Access Compliance Report

Public Rights-of-Way

Intersection ID: 13654	Main Street: S_TRYON_ST	Cross Street: W_PARK_AV	Location: E
ADA ID: 9578CA6AE103	Ramp Type: PerpDiag	Initial Pass/Fail: Fail	Overall Compliance: No
		Severity Score: 12.5

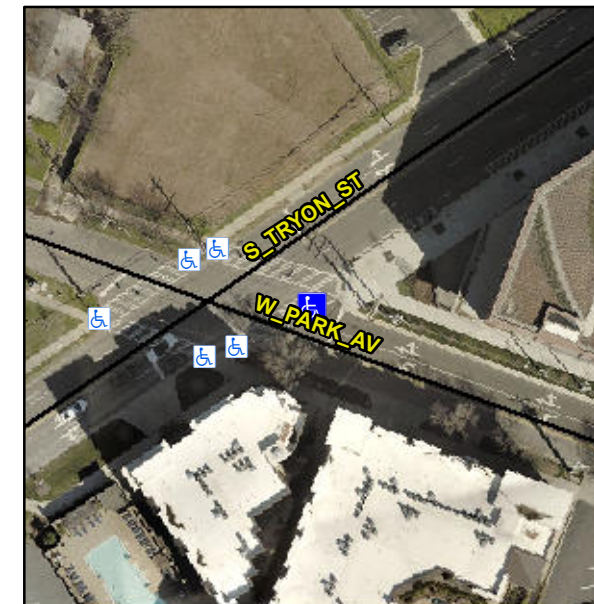
R304.2.2

Compliance	Description	Data	Compliance	Description	Data
N/A	Ramp Length (in)	48.0	No	Ramp Slope (%)	11.5
Yes	Ramp Width (in)	48.0	Yes	Ramp XSlope (%)	0.3
N/A	Flare Type LT	N/A	N/A	Flare Type RT	N/A
N/A	Flare Slope LT (%)	N/A	N/A	Flare Slope RT (%)	N/A
N/A	Flare Traversable LT?	N/A	N/A	Flare Traversable RT?	N/A
N/A	Landing Length (in)	N/A	N/A	DWS Provided?	N/A
N/A	Landing Width (in)	N/A	N/A	DWS Contrast?	N/A
N/A	Landing Slope (%)	N/A	N/A	DWS Length (in)	N/A
N/A	Landing X Slope (%)	N/A	N/A	DWS Full Width?	N/A
N/A	Landing Curb? (Y/N)	N/A	N/A	DWS Offset (in)	N/A
N/A	Shared Landing?	N/A			
N/A	Gutter Ponding?	N/A	N/A	Gutter Slope (%)	N/A
N/A	Gutter Lip Ht (in)	N/A	N/A	Gutter X Slope (%)	N/A
N/A	Painted X Walk1?	Yes	N/A	Painted X Walk2?	Yes
	X Walk 1 Direction	To NW		X Walk 2 Direction	To SW
N/A	X Walk 1 Width (in)	88.0	N/A	X Walk 2 Width (in)	111.0
	X Walk 1 Slope (%)	4.2		X Walk 2 Slope (%)	1.5
	X Walk 1 X Slope (%)	2.2		X Walk 2 X Slope (%)	2.0

Remove & Replace Curb Ramp With Two New Directional Ramps or Equivalent.
